**Town of Davidson
Design Review Board Regular Meeting
Town Hall and Community Center
Community Room 120
251 South Street
Wednesday, September 18, 2024 at 5:30 PM**

Date: September 18, 2024
To: Design Review Board
From: Lindsay Laird, Senior Planner
Re: Summit Farms Roastery Building – Decision Meeting #1

Summit Farms Roastery Building

Design Review Board Submission
Approval Application

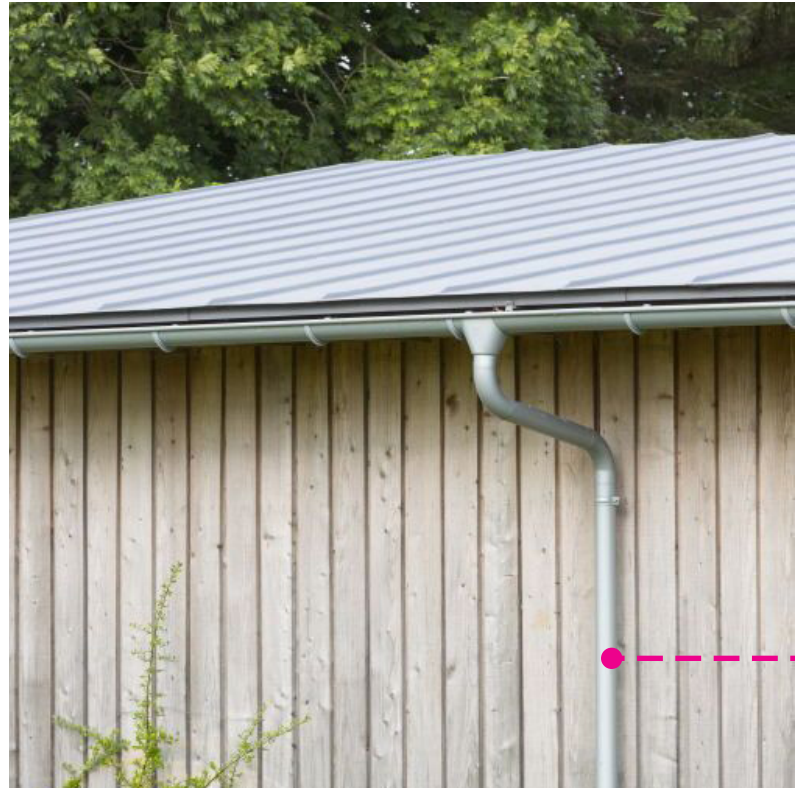
Roof edges should be studied with regard to drainage.

Valley between gables should be studied in regard to drainage and potential mechanical equipment location. Equipment should not be visible from street.

Roof over second floor office dormer should be sloped rather than flat.

Horizontal material change should be studied to more fully align with North Carolina agricultural vernacular.

Compliance w/ Davidson Planning Ordinance (DPO) Section 4.5.6

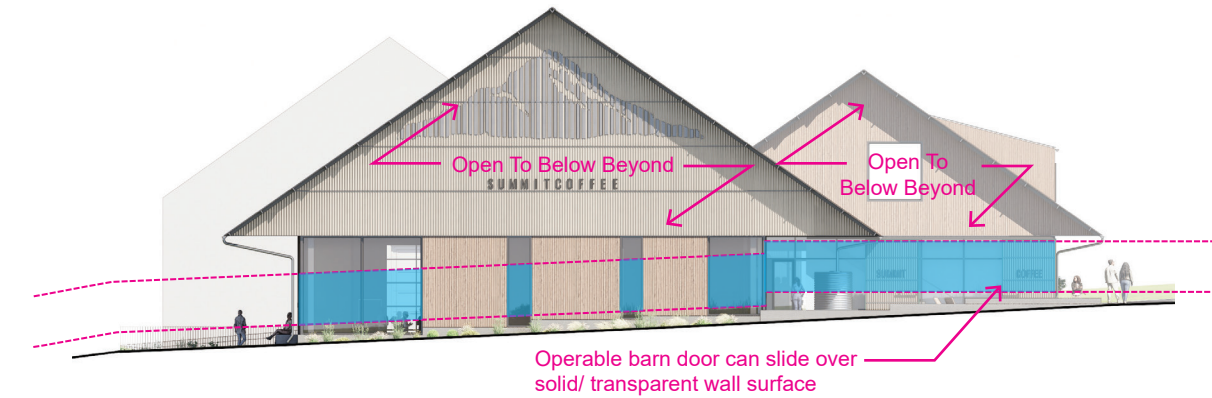
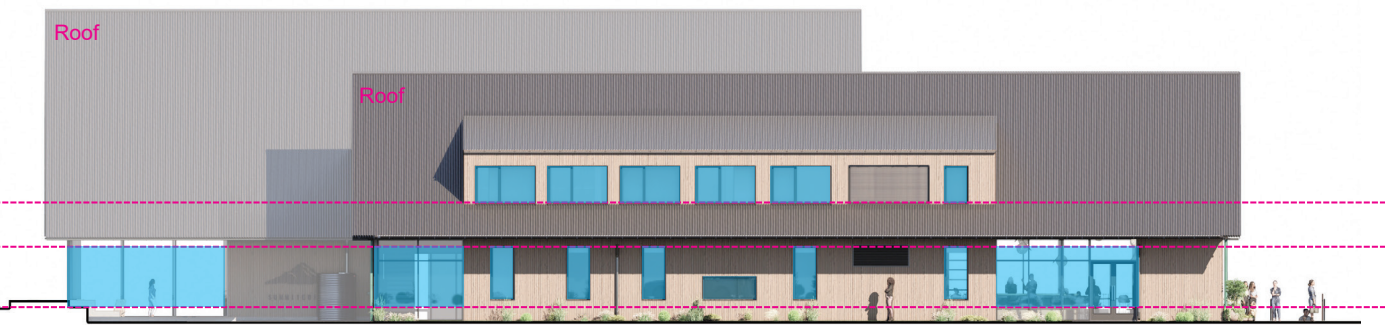
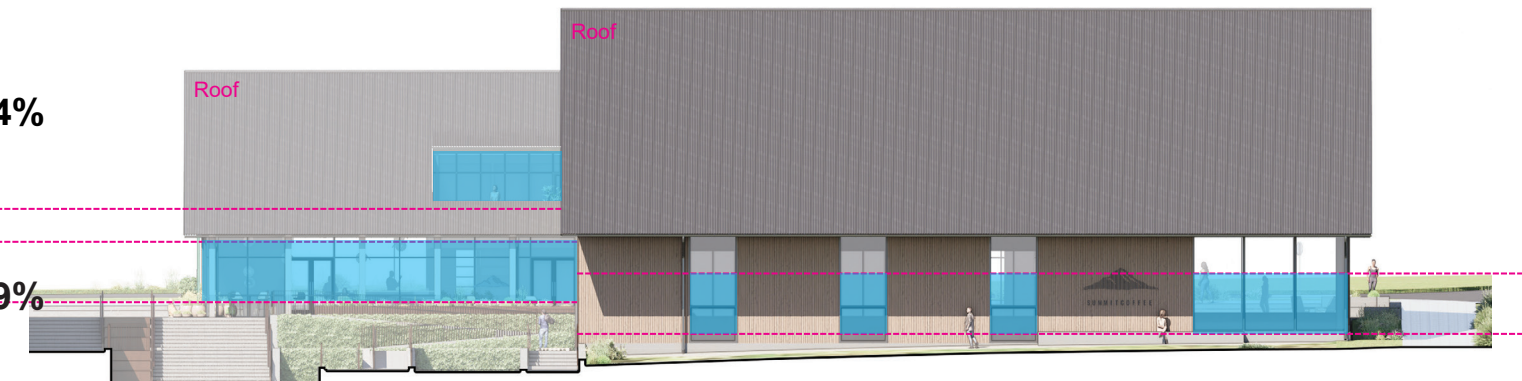
- **4.5.6.I Secondary Entrances:** Compliant
- **4.5.6.J.1 Use Requirements NS Overlay:** Compliant (Commercial/Retail Use)
- **4.5.6.J.2 Roof Form:** Compliant (Shall not be flat)
- **4.5.6.J.3 Transparency NS Overlay:** Compliant based on glazing calcs. provided by applicant (For storefront buildings located in the Neighborhood Services Overlay, at least 50% of the first-floor façade between 2'-0" and 10'-0" above grade facing the primary streets must be transparent and at least 30% of the upper floor facades between 3'-0" and 37'-0" above finished floor must be transparent.)
- **4.5.6.J.4 Materials NS Overlay:** Building design shall use materials consistent with rural vernacular architecture (see figure 1. precedent images from Rural Area Plan below).
Confirm design/materials is consistent with rural vernacular architecture.

$$\text{GF } \frac{550 \text{ SF GLAZING AREA}}{800 \text{ SF TOTAL AREA}} = 68.8\%$$

$$\text{GF } \frac{437 \text{ SF GLAZING AREA}}{800 \text{ SF TOTAL AREA}} = 54.6\%$$

$$\text{L2 } \frac{222 \text{ SF GLAZING AREA}}{511 \text{ SF TOTAL AREA}} = 43.4\%$$

$$\text{GF } \frac{613 \text{ SF GLAZING AREA}}{1220 \text{ SF TOTAL AREA}} = 50.2\%$$

$$\text{L2 } \frac{98 \text{ SF GLAZING AREA}}{125 \text{ SF TOTAL AREA}} = 78.4\%$$

$$\text{GF } \frac{708 \text{ SF GLAZING AREA}}{1222 \text{ SF TOTAL AREA}} = 57.9\%$$
